#### GENOA CHARTER TOWNSHIP PLANNING COMMISSION PUBLIC HEARING MARCH 25, 2013 6:30 P.M. AGENDA

**OPEN PUBLIC HEARING #1**...Review of special use application, environmental impact assessment and site plan for a proposed 20,680 sq. ft. office building located on the South side of Grand River Avenue between Hughes Road and Kellogg Road in Section 14, petitioned by Dakkota Integrated Systems.

Attention:	Kelly Van Marter, AICP	1
	Assistant Township Manager and Planning Director	
Subject:	Dakkota Integrated Systems – Special Land Use and Site Plan Review #1	
Location:	Vacant property on the south side of Grand River Avenue, east of Dorr Road	
Zoning:	OSD Office Service District

#### Re: Dakkota Integrated Systems Corporate Office Site Plan Review #2

TWP. REVIEW NO BY CK REVISION PFR

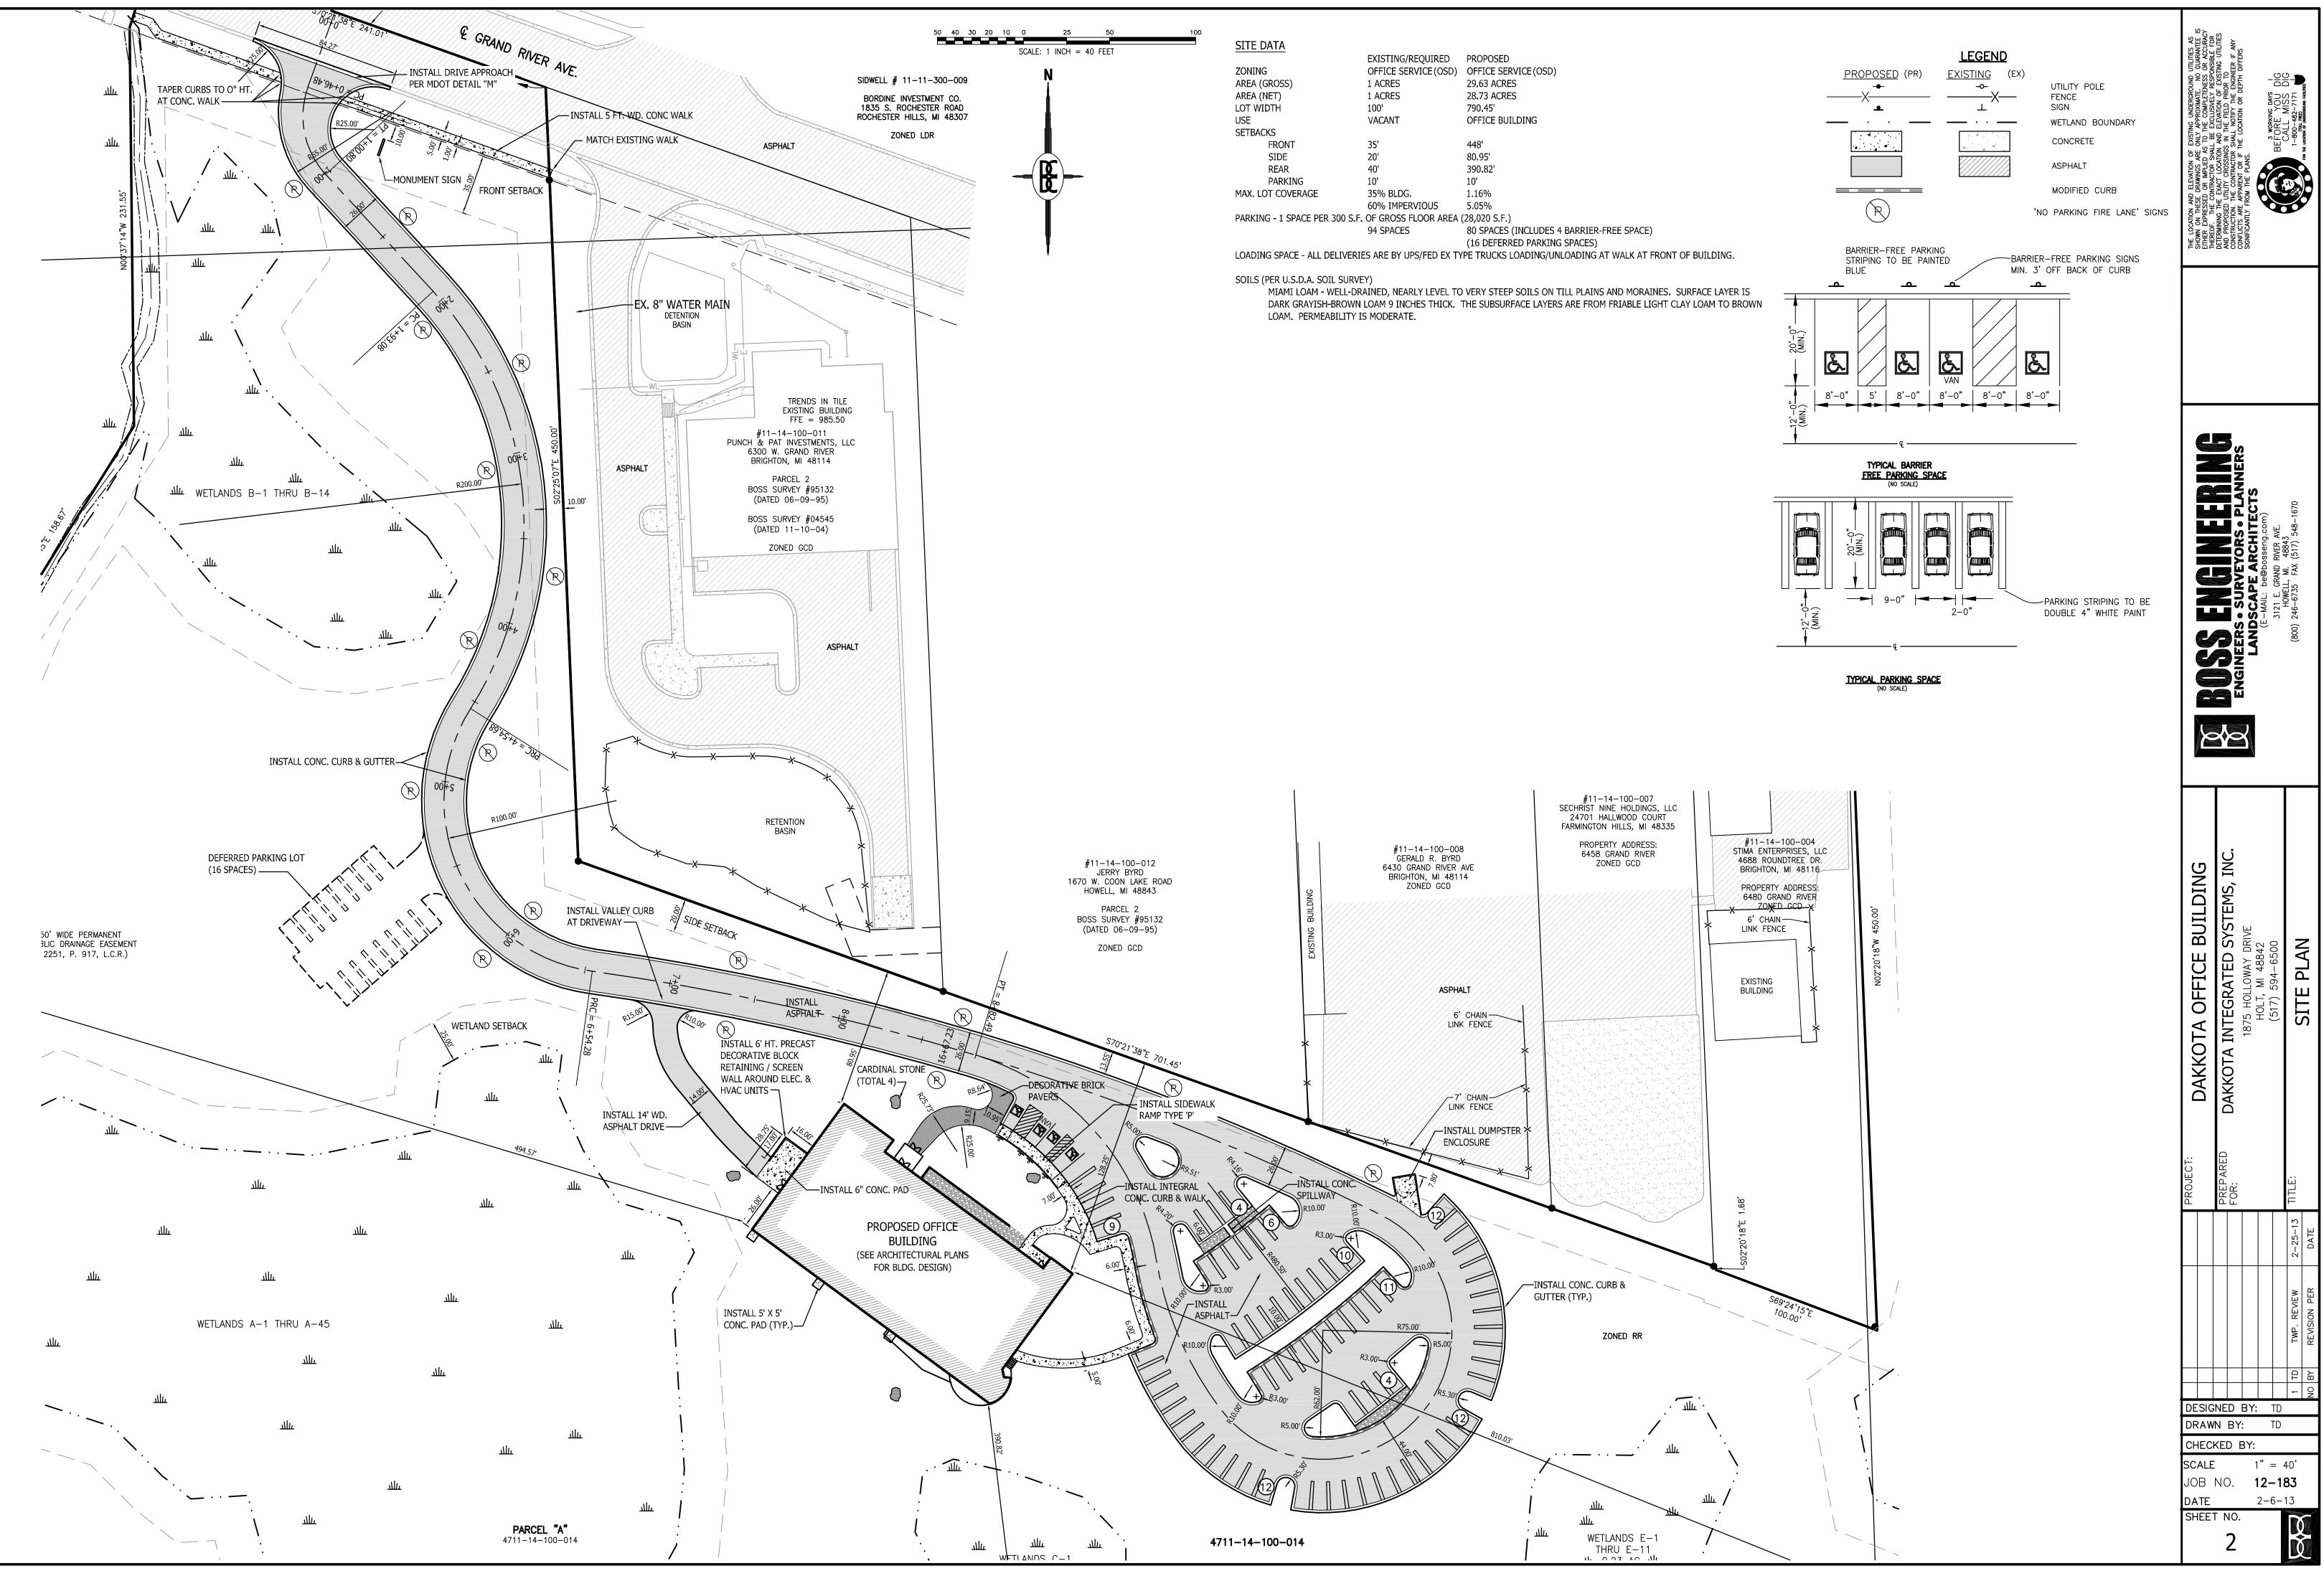
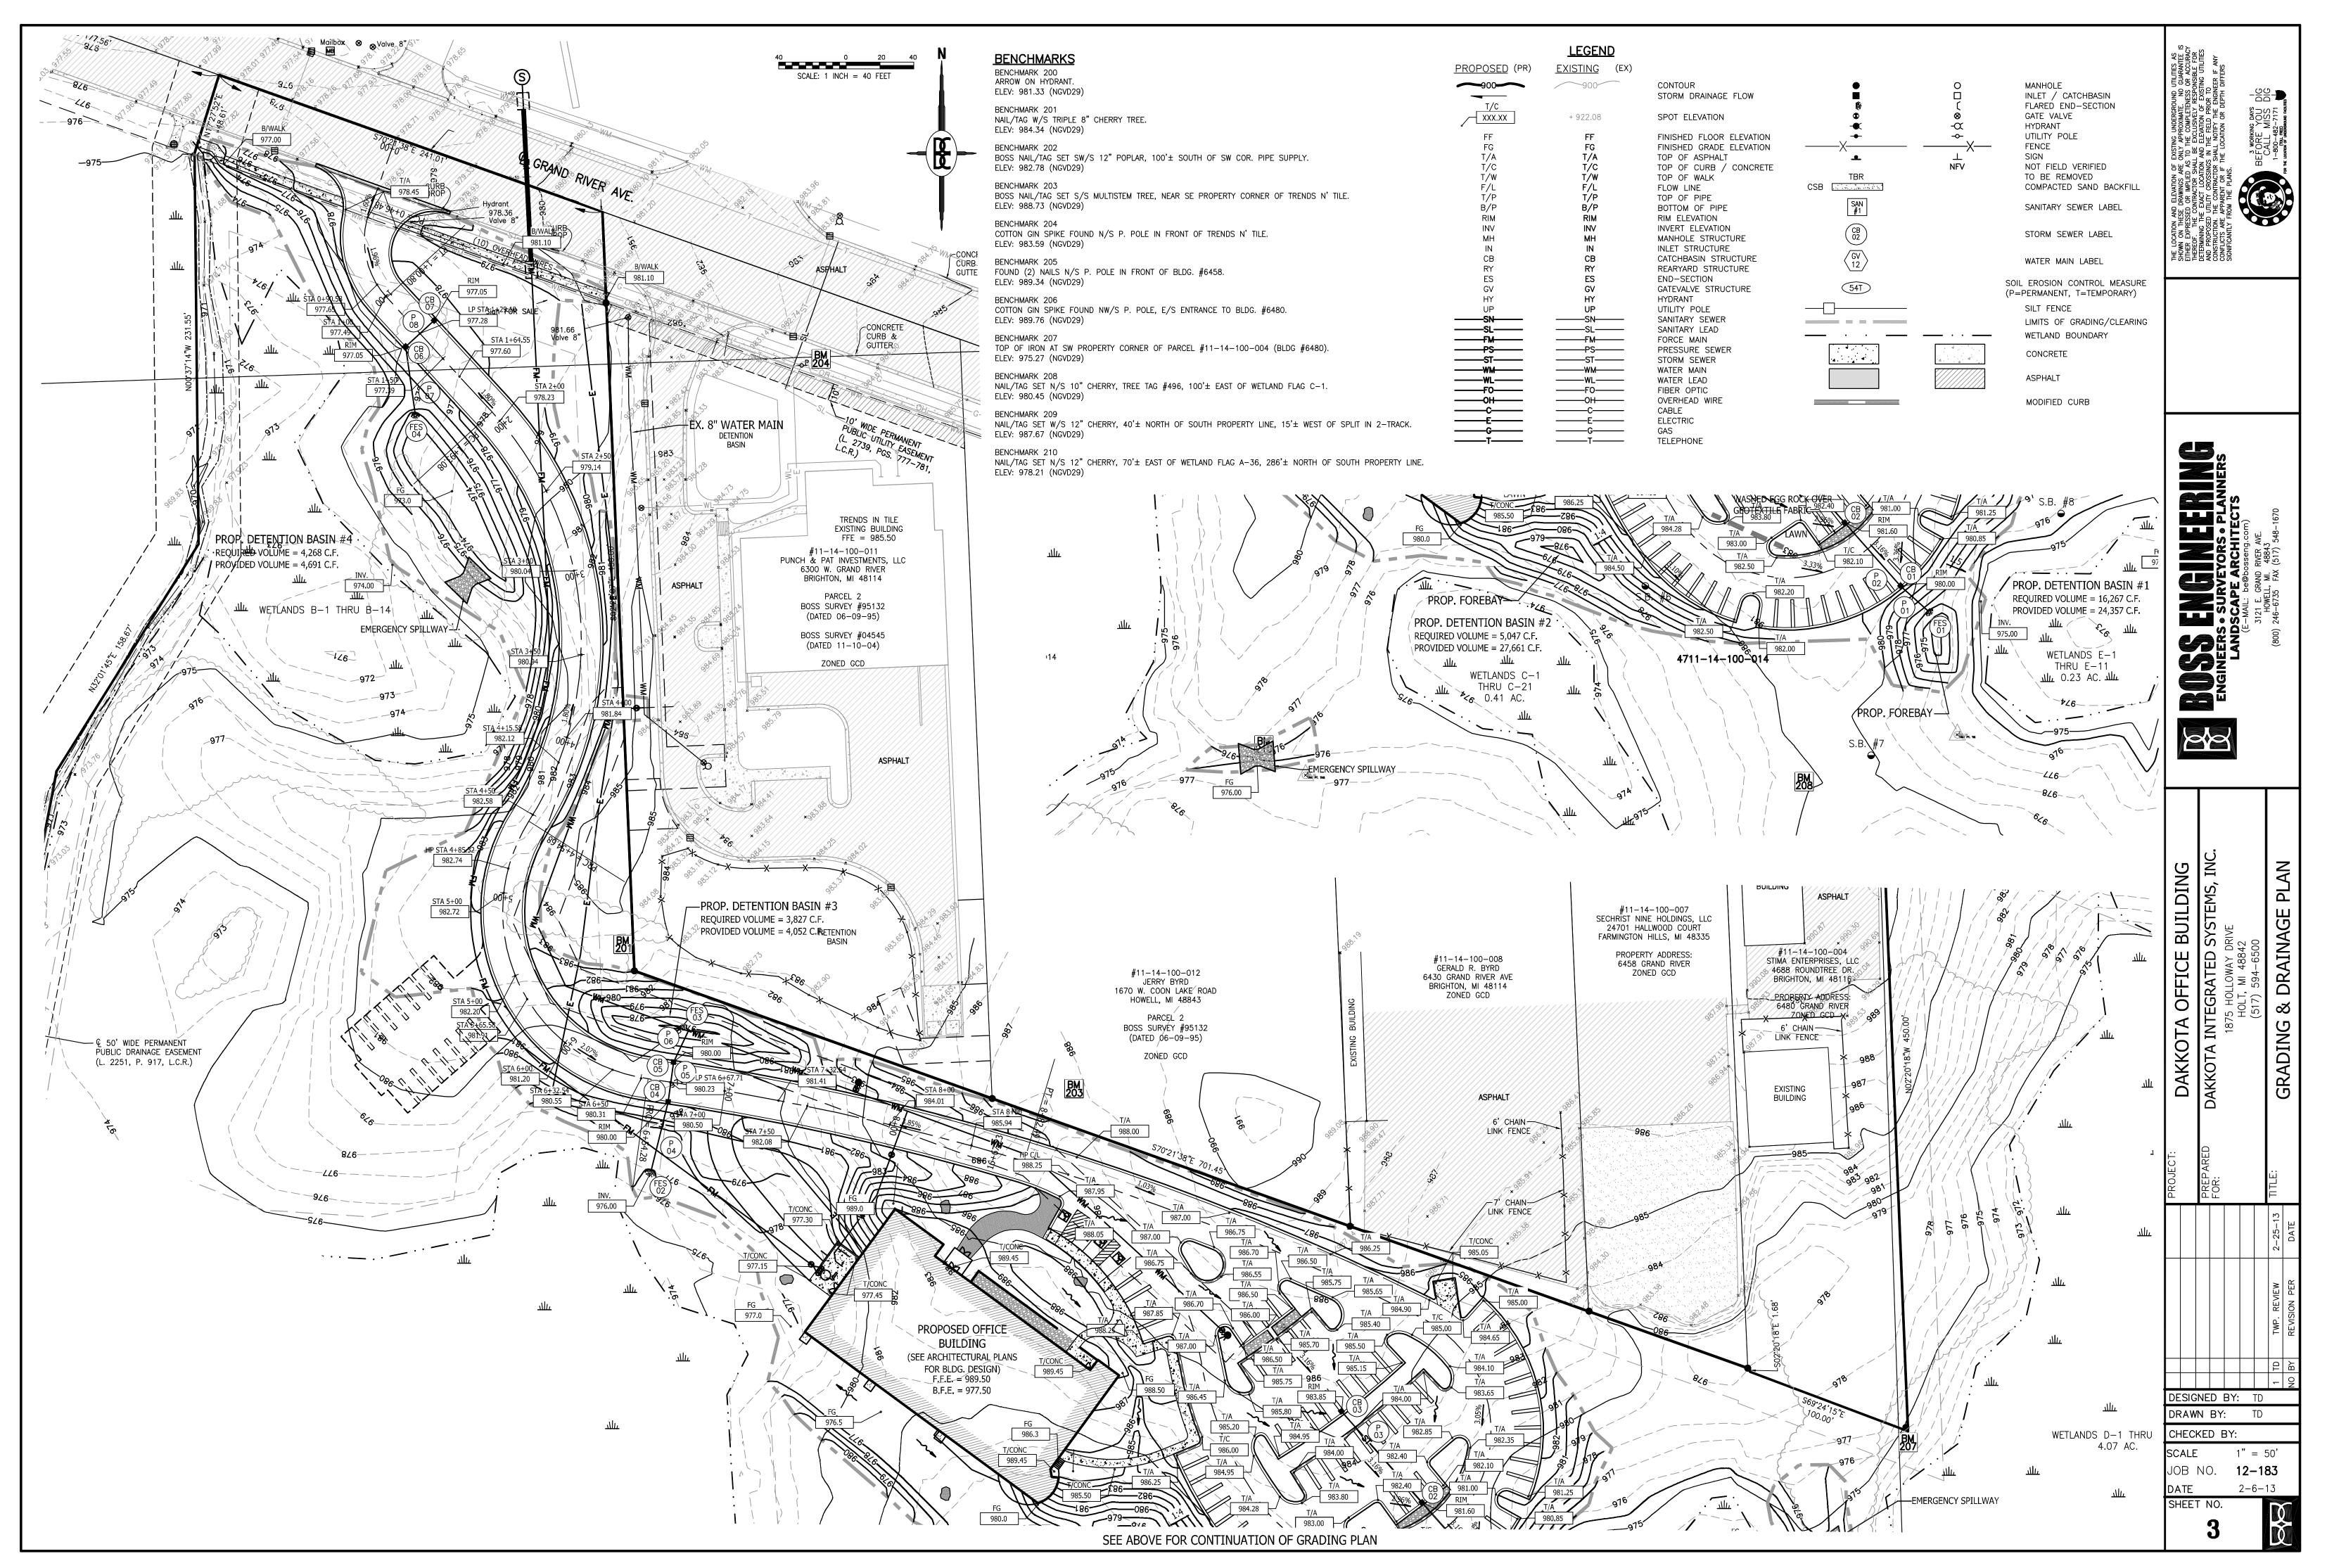
- 4. The site plan does not identify the required loading space.
- 5. The applicant requests Commission authorization to modify landscaping requirements given the presence of existing natural vegetation and wetlands.

- 6. There are minor discrepancies on the landscape plan that need to be corrected.
- 7. The applicant must confirm that irrigation will be provided for all proposed landscaped areas.

5. Loading. Given the size of the building, Section 14.08.08 requires 1 loading space, which is to be located in a rear or side yard not directly visible to a public street. The site plan does not identify the required space, which is to contain 500 square feet, unless otherwise approved by the Planning Commission.

Additionally, there are some minor discrepancies between the landscape plan and table on Sheet 6. Specifically, the following items must be corrected for consistency:

- The table identifies 7 "QR" trees, although the plan depicts only 6;
- The plan notes 1 "PS" tree southeast of the building, although 2 are shown;
- The table identifies 31 "FIS" shrubs, although the plan depicts 37;
- The table identifies 15 "HPL" shrubs, although the plan depicts only 8;
- The table identifies 12 "HB" perennials, although the plan depicts only 7; and
- The plan identifies a shrub noted as "CAK" that is not described in the table.

The plan also shows 14 evergreen trees along the southerly lot line to fill in gaps between existing plantings; however, there is no indication as to their size or type. These plantings must be included in the table along with their details. Lastly, the applicant must confirm that irrigation will be provided for all landscaped areas in accordance with Section 12.02.11.

7. Waste Receptacle and Enclosure. The project includes a new waste receptacle and enclosure northeast of the building. Section 12.04 requires a rear yard or non-required side yard location, unless otherwise approved by the Planning Commission. Given the proposed placement within the required side yard (7.8-foot setback provided; 20-foot required), the location requires Commission approval.

- 9. Exterior Lighting. The submittal includes a photometric plan (Sheet 7), which proposes the installation of 5 light poles in the parking lot (3 of which have double fixtures), 25 bollards along the driveway and 2 fixtures used to illuminate the proposed ground sign. The pole mounted fixtures are at a height of 20 feet and the photometric readings are well within Ordinance limitations. Our only comment is that the applicant needs to provide detail sheets for the proposed fixtures.
- 10. Signs. The submittal proposes a monument sign near the driveway, as well as two wall signs on the building itself. The ground sign complies with Ordinance standards for height, area and setback; however, the inclusion of two wall signs requires Commission approval in accordance with Footnote 2(b) of Table 16.1.

- 1. The minimum listed setback along parking areas is 10 feet, yet there is only a 7.8-foot setback from the dumpster enclosure to the north property line adjacent to 6430 Grand River Avenue. If a variance is being requested, it should be stated on the plans.

- 2. Water main is shown connecting off the existing water main stub on the property of 6300 Grand River Avenue. The connection is proposed as a tapping sleeve and valve. This section of line can be isolated, so the connection should be revised to be a cutting-in sleeve and tee on the 8-inch water main. Calculations are needed for water usage and fire flow demand to confirm that the necessary capacity is available at the proposed tapping location for the MDEQ water main permit.

- 3. A fire department connection has been added to the NW corner of the building. Is piping to connection going to be all internal to building? If not, show exterior piping and provide a detail for the fire department connection and how it is isolated with a check valve from the public system.

Show limits of proposed bore pits on both sides of the road as the bore pit locations currently shown are in conflict with existing water mains.

- 1. The use group and type of construction was not indicated in the initial submittal. Provide this information to the Brighton Area Fire Department.
- 2. The water main shall be sized in such a way as to meet the requirement set out in the International Fire Code 2012 Appendix B Table B105.1 and Table C105.1. Provide the location of the water main and the closest hydrant to the site. A hydrant shall be located within 100' of the fire department connection.

6. The access road into the site shall be a minimum of 26' wide. With a width of 26' wide, one side of the street shall be marked as a fire lane. Include the location of the proposed fire lane signage and include a detail of the fire lane sign in the submittal. Access roads to site shall be provided and maintained during construction. Access roads shall be constructed to be capable of supporting the imposed load of fire apparatus weighing at least 75,000 pounds.

- 7. Access around building shall provide emergency vehicles with a turning radius up to 55' wall to wall and a minimum vertical clearance of 13 ½ feet.
- 8. The location of a key box (Knox Box) shall be indicated on future submittals. The Knox box will be located adjacent to the front door of the structure.
